DRAFT CHAPTER N3: BERRY RESIDENTIAL SUBDIVISION

Table of Changes

Figure 1: Subject Land Map

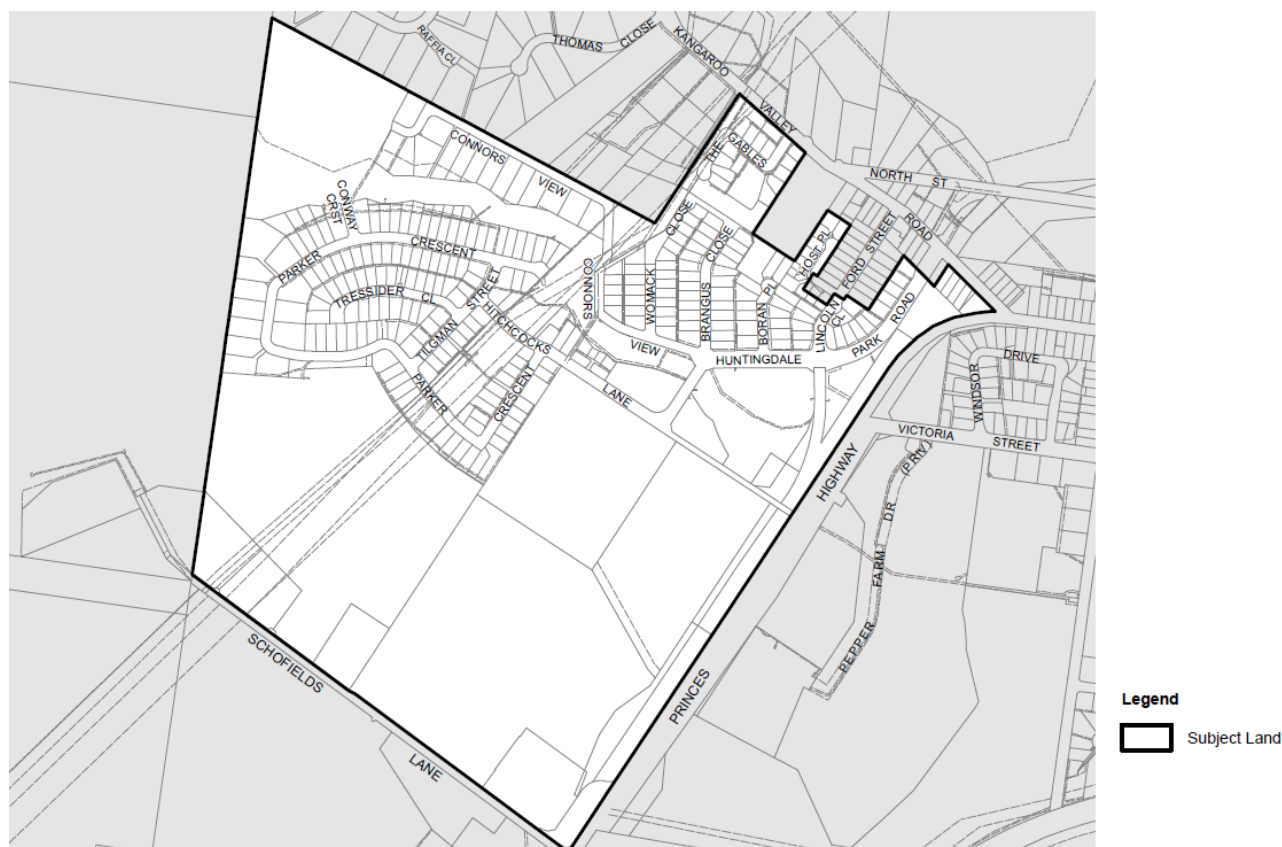
2	2	Update	Update Subject Land Map.	Change figure to show updated property boundaries for Huntingdale Park subdivision and Princes Highway bypass. Subject land extent does not change.

Figure 4: Indicative Layout Plan Hitchcocks Lane Subdivision

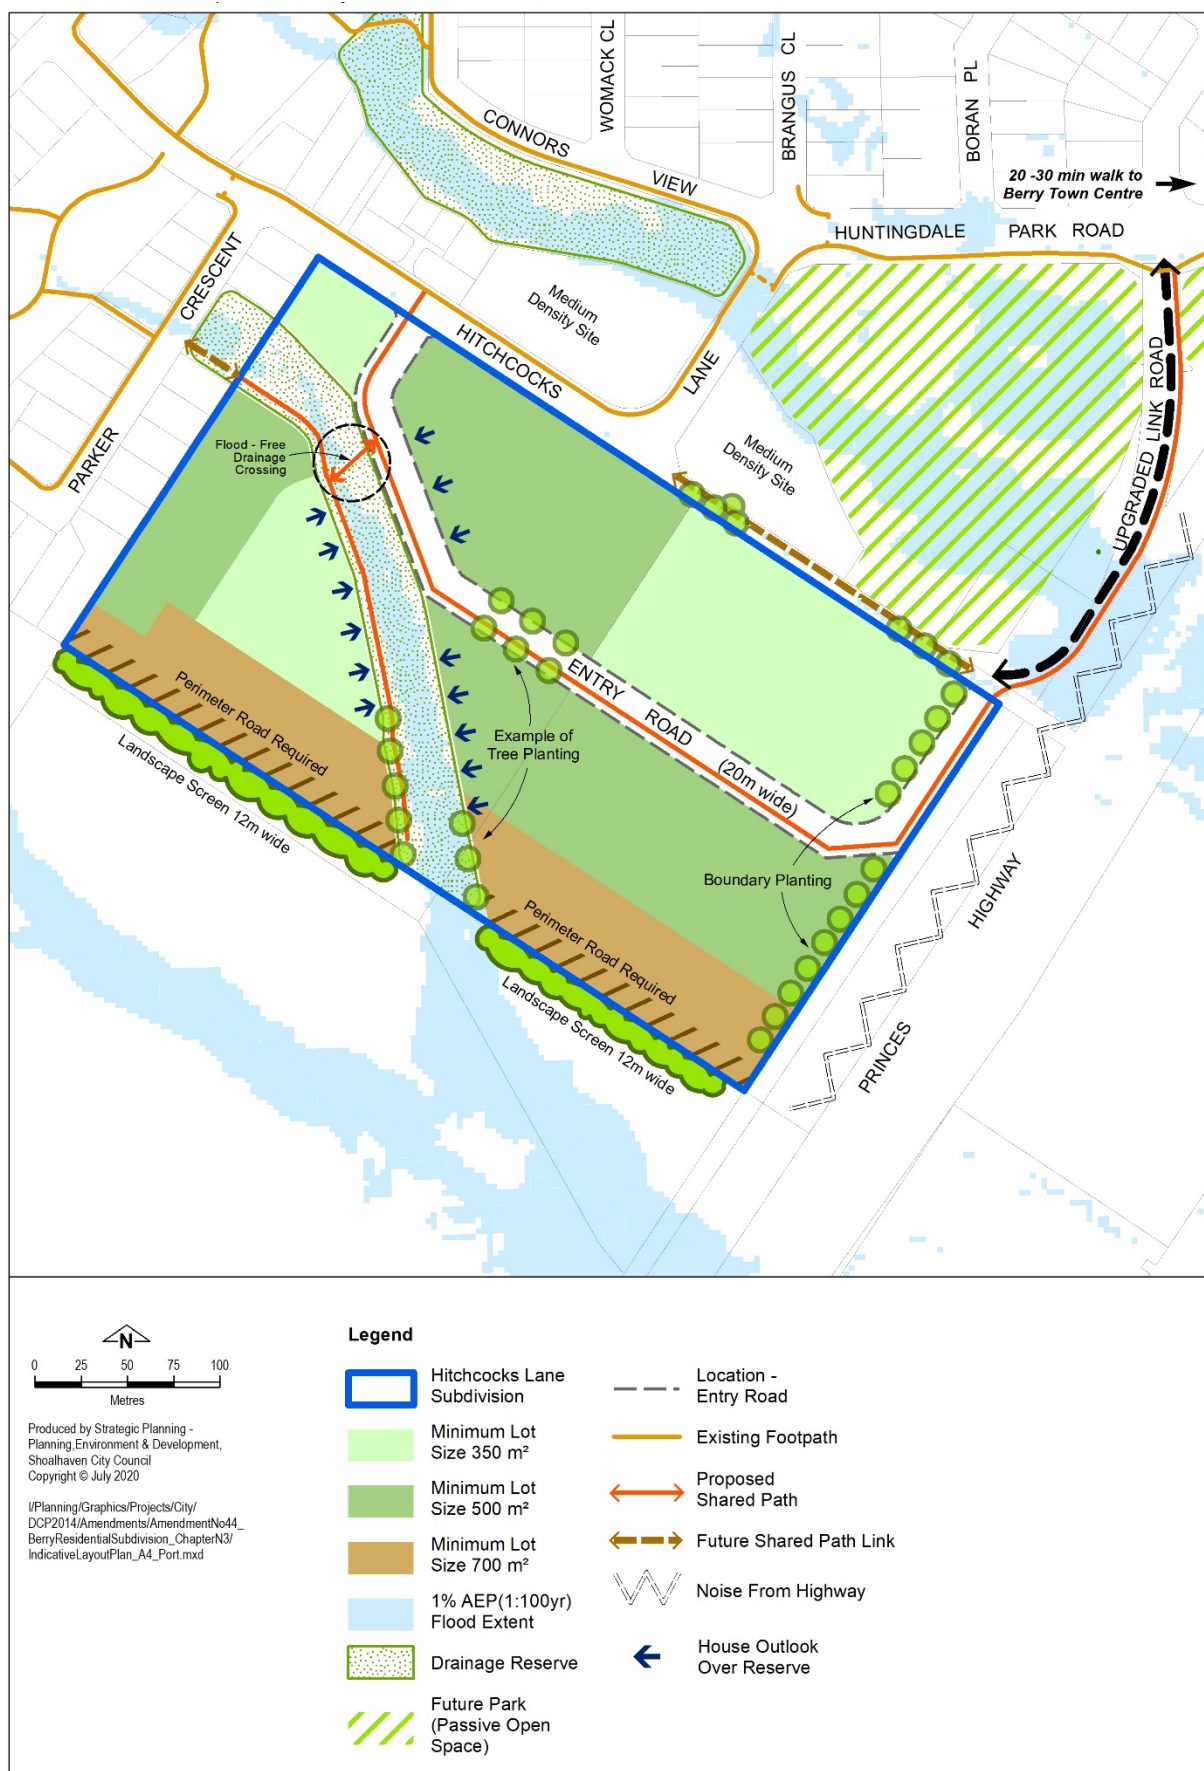
-	6.1	New	<p>Provide an Indicative Layout Plan (ILP) for Hitchcocks Lane new residential area and controls requiring development to be consistent with the ILP.</p>	<p>To present development controls for the new residential area graphically and to summarise development outcomes in a user-friendly manner.</p>

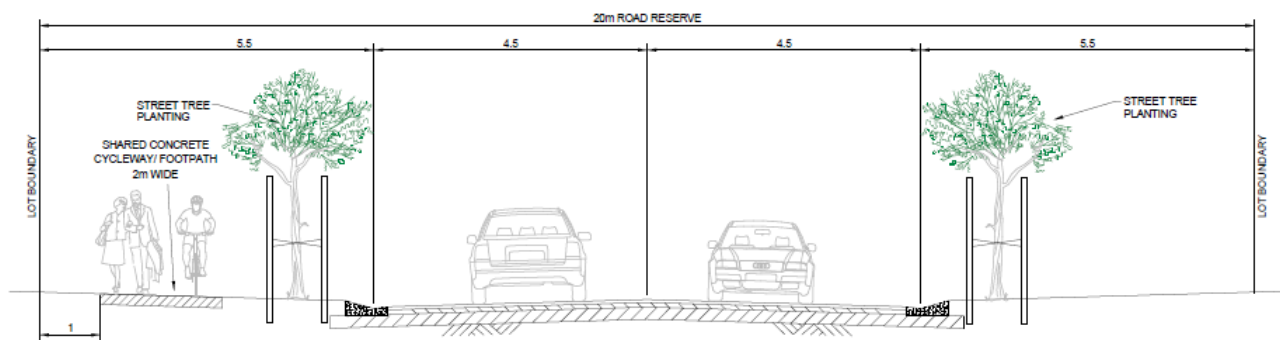
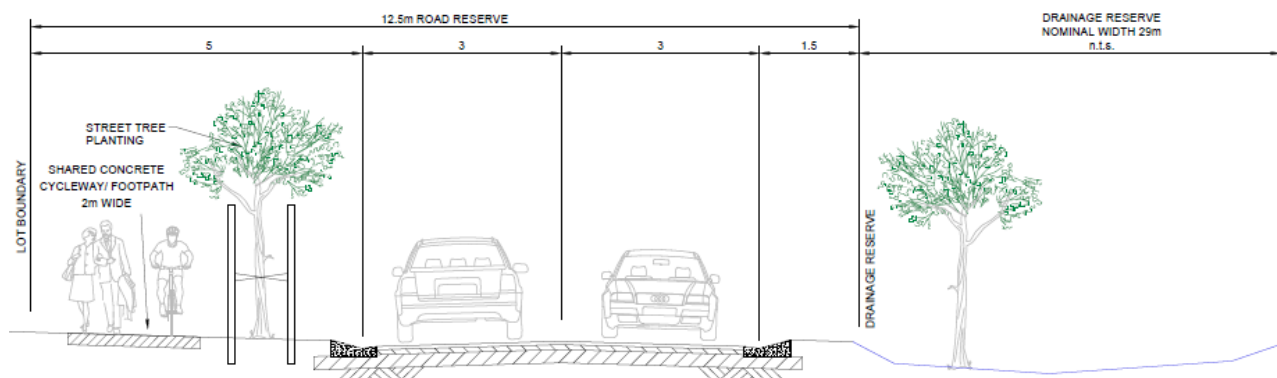
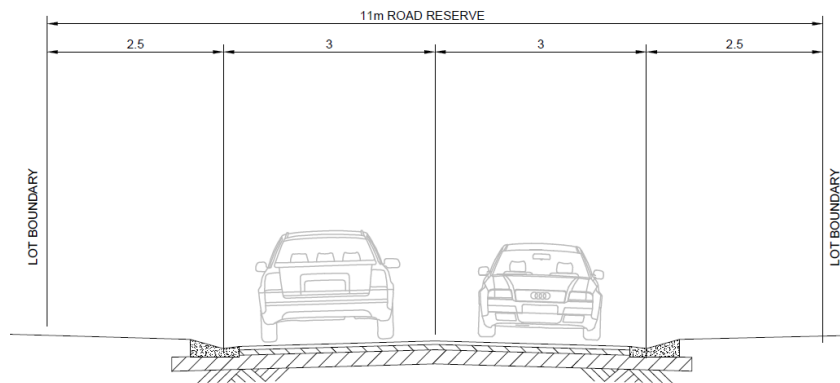
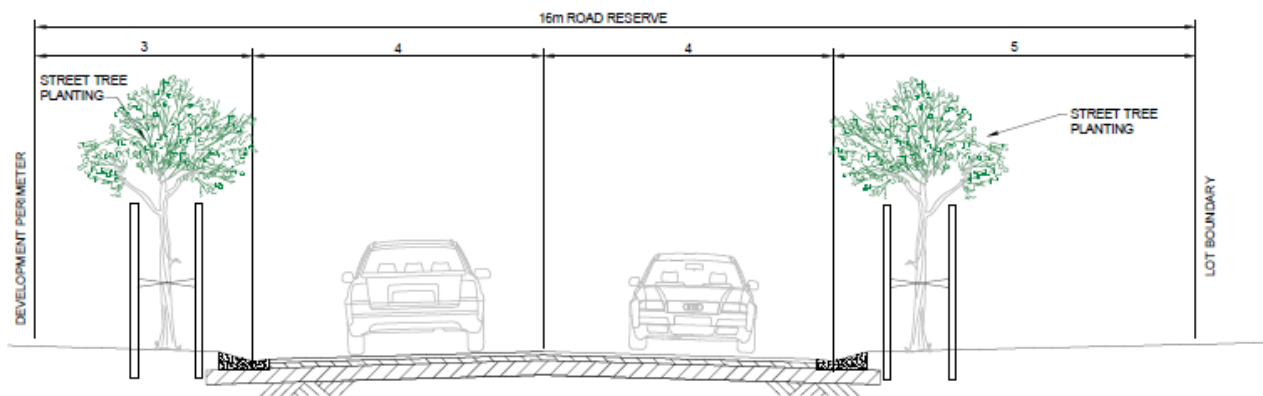
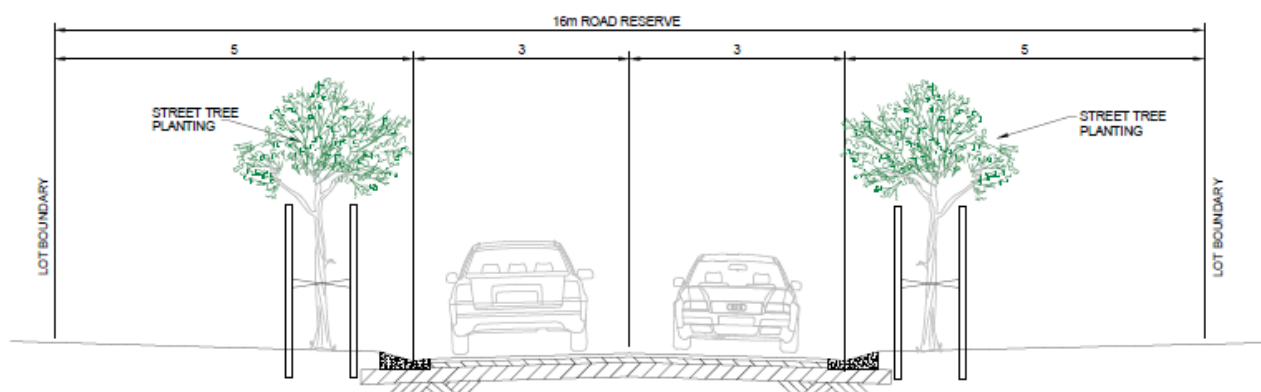
-	9	New	Include all road reserve design specifications in an Appendix	Provide minimum road reserve widths and specifications for all proposed streets to ensure street design provides for efficient and safe traffic flows and provides amenity to the subdivision.
